REV.
A

AS3508

INSERT - THIN WALL,
SHORT AND LONG
HOLE PREPARATION FOR

FIGURE 1 - INSERT INSTALLATION HOLE PREPARATION

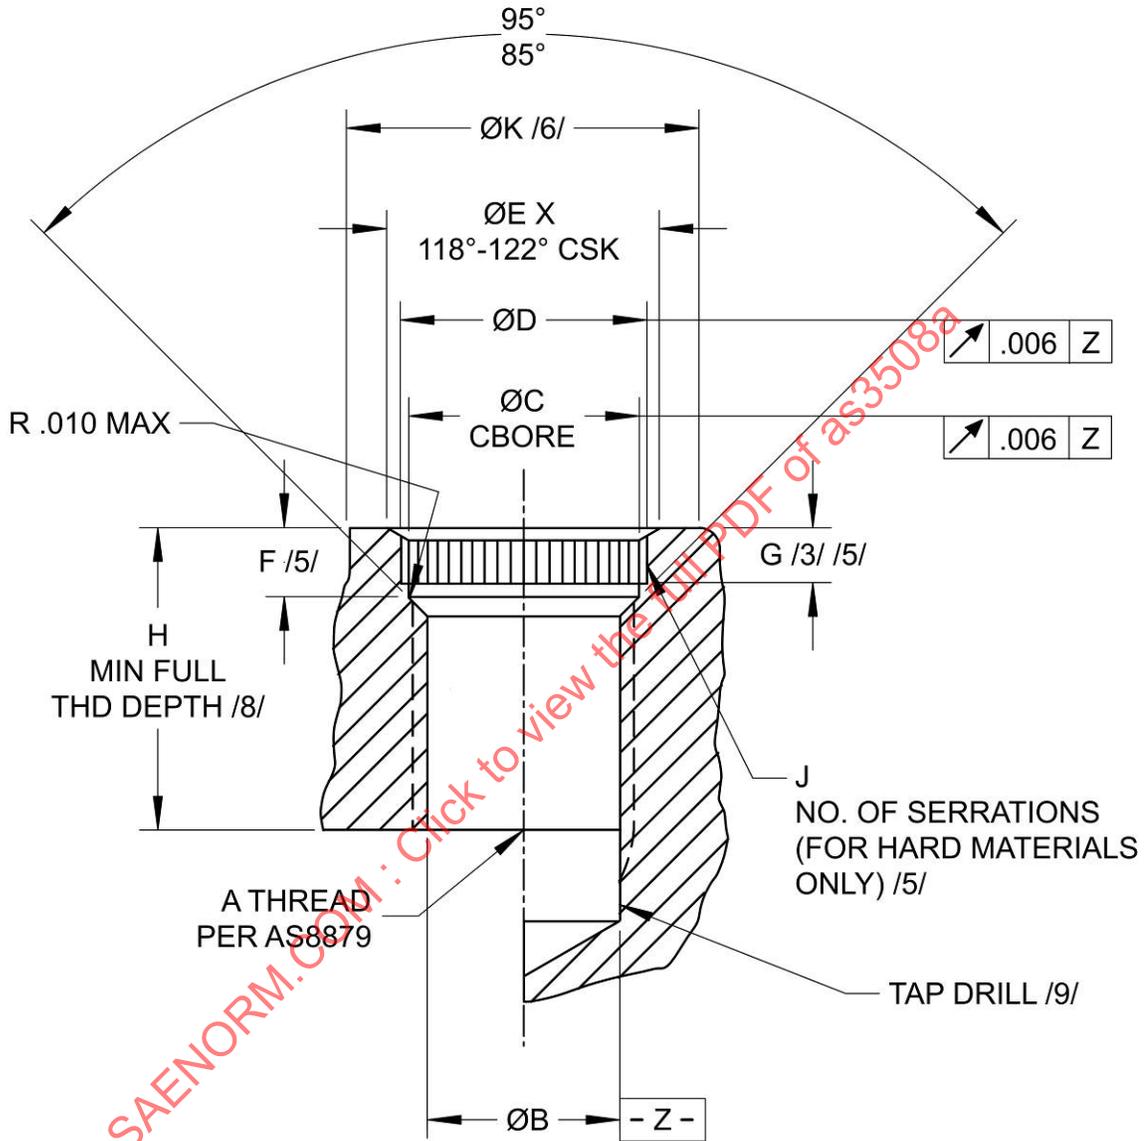
REVISE THREAD SPECIFICATION TO AS8879. ADD MAX RAD TO BOTTOM OF CBORE, ADD ANSI Y14.5M-1982. REVISE COUNTERBORE DEPTH, DIM F, FOR HOLES WITH SERRATIONS, REVISE DIM B TOLERANCE, ADD NOTE FOR FULL THREAD DEPTH IN BLIND HOLES, GENERAL EDITORIAL UPDATE INCLUDING FIGURE 1 REDRAWN UPDATED AND TABLE 1 FORMAT UPDATED.
